FIRE SAFETY INSPECTION REPORT

TUSUKA JEANS & POLO LTD.
PLOT-B-91, BSCIC, TONGI I/A, GAZIPUR

ACCORD
on Fire and Building Safety in Bangladesh

March 20, 2014

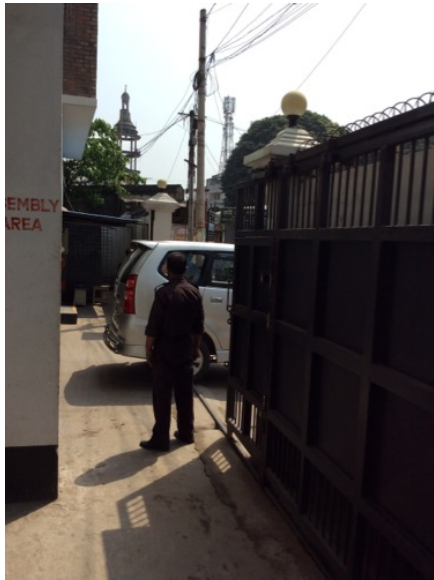
F-6	Fire Rated Construction	Areas used for combustible storage at 2nd floor is not separated by fire-rated construction.	Provide dedicated storage rooms separated by minimum 1-hr fire-rated construction. Where separate storage rooms are not feasible, provide defined storage areas and limit the storage arrangement as follows: - Maximum height of 2.4m and maximum area of 23m² - If sprinkler protected: maximum height of 3.66m and maximum area of 93m² Separate areas of unenclosed combustible storage by a minimum clear distance of 3m.	Within 3 months
-----	-------------------------	--	--	-----------------

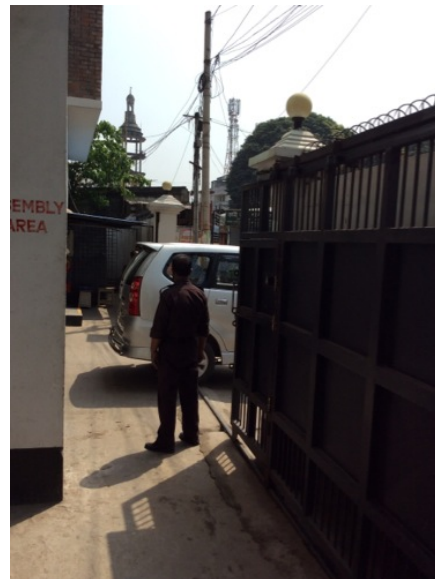
F-9	Egress	Combustible and a wastebasket were located in the exit stairs.	Remove all combustible (curtains and notice wood board) and wastebasket from the exit stairs.	Immediate
-----	--------	--	---	-----------
